21-COA-0152
1201-05 S. 3rd St.

Old Louisville Architectural Review Committee
Public Hearing

Bradley Fister, Historic Preservation Specialist
September 22, 2021

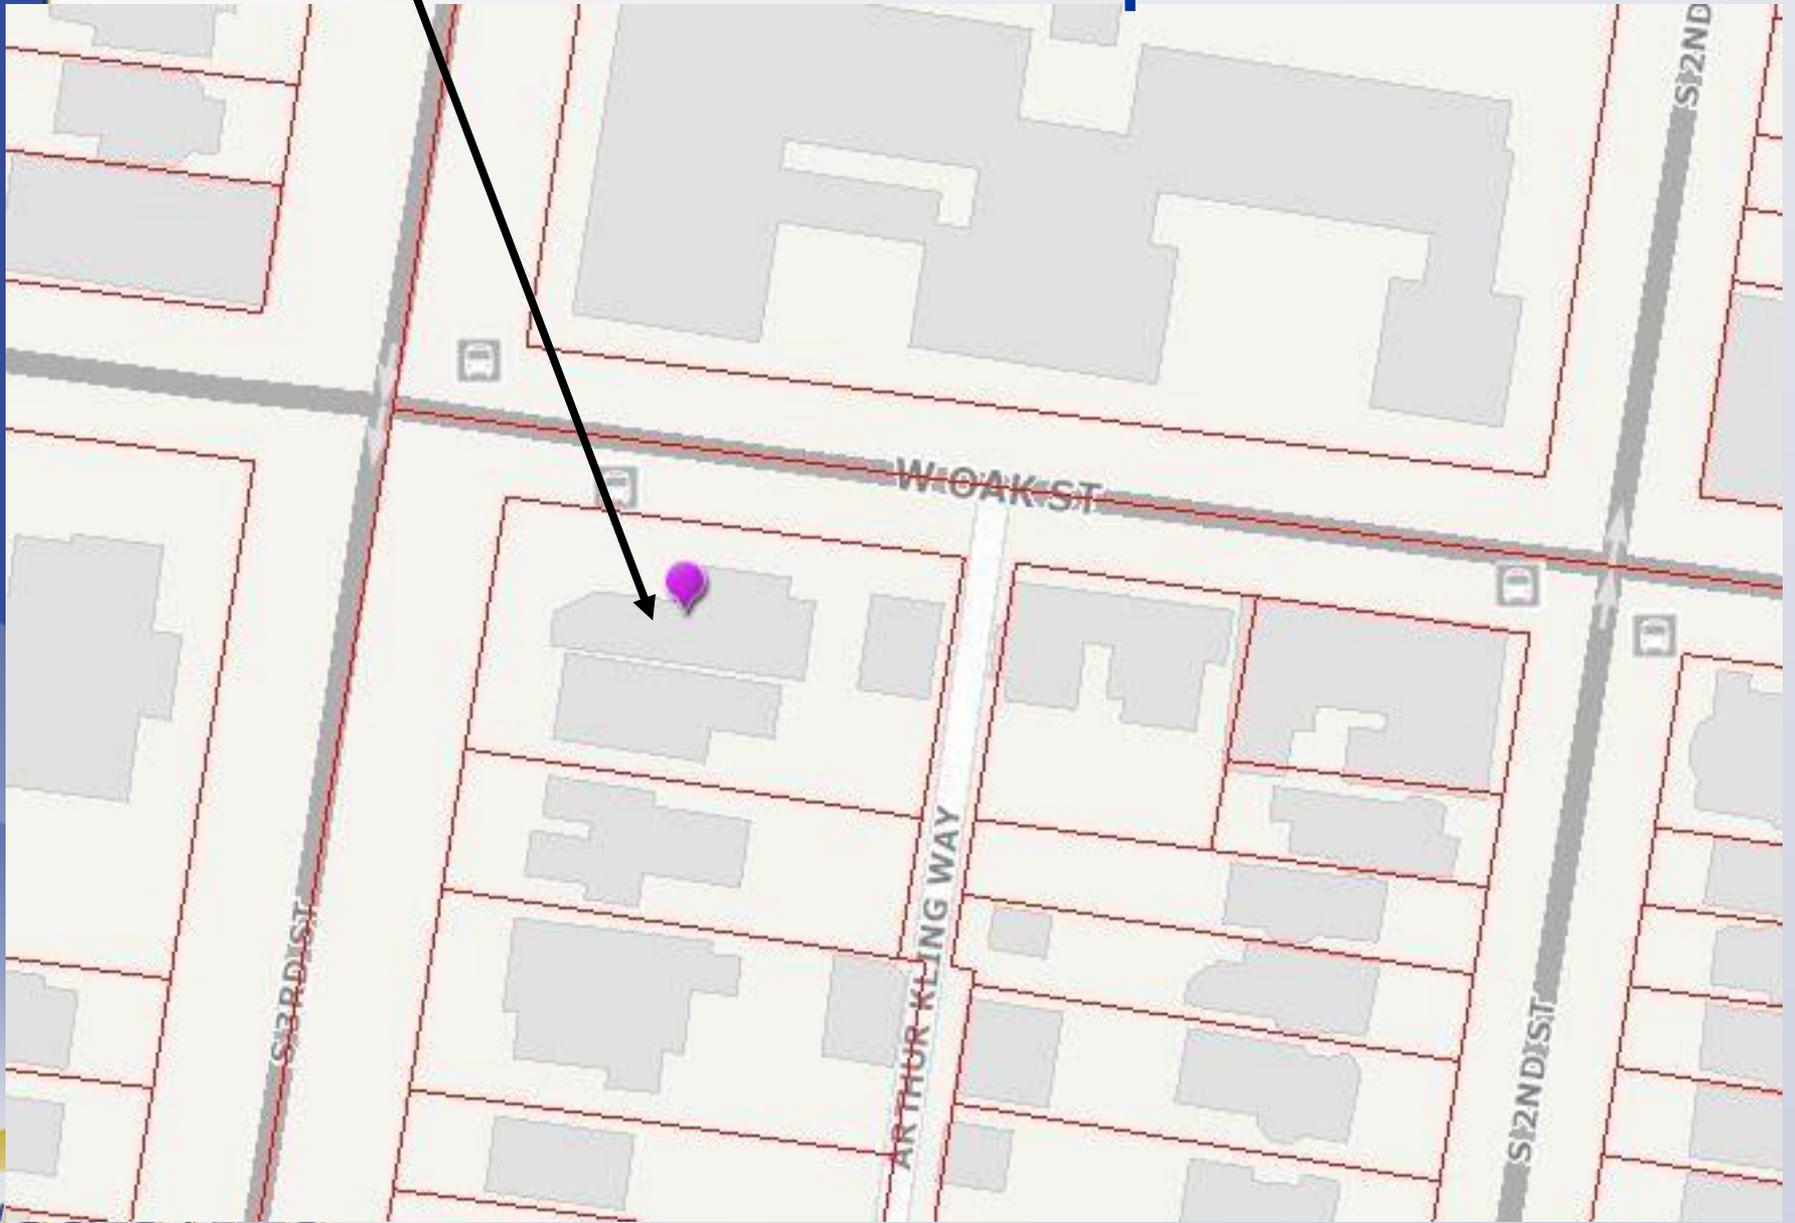
At the point where the pergola is proposed to adjoin the Oak St. sidewalk, the curb is proposed to end, and become a low, articulated wall for sound attenuation and privacy as well as providing a seat wall on the dining area side. Plantings are proposed to be added to vine over the pergola. At the west end of the pergola, is proposed to be an approximately 400 sf addition to the building, to provide a space for deliveries and enclosed trash storage.

The proposed location of the approximately 42” seating wall along the side of the building that faces W. Oak St. generally does not meet the Old Louisville Design Guidelines for **Site**. The primary conflict with the Design Guidelines relates to **ST10** which states not to install masonry walls in street visible locations unless they are used to retain earth or there is an historic precedent, and **ST16** that states not to install concrete block walls in street visible locations.

- 1. The proposed wall along the Oak St. site side shall be deleted from the plan.**
- 2. The applicant shall use historic concrete mix, for any and all concrete visible from the street**
- 3. The applicant shall provide staff with material cut sheets for all products proposed to be used prior to construction.**
- 4. The applicant shall obtain any and all necessary work permits.**
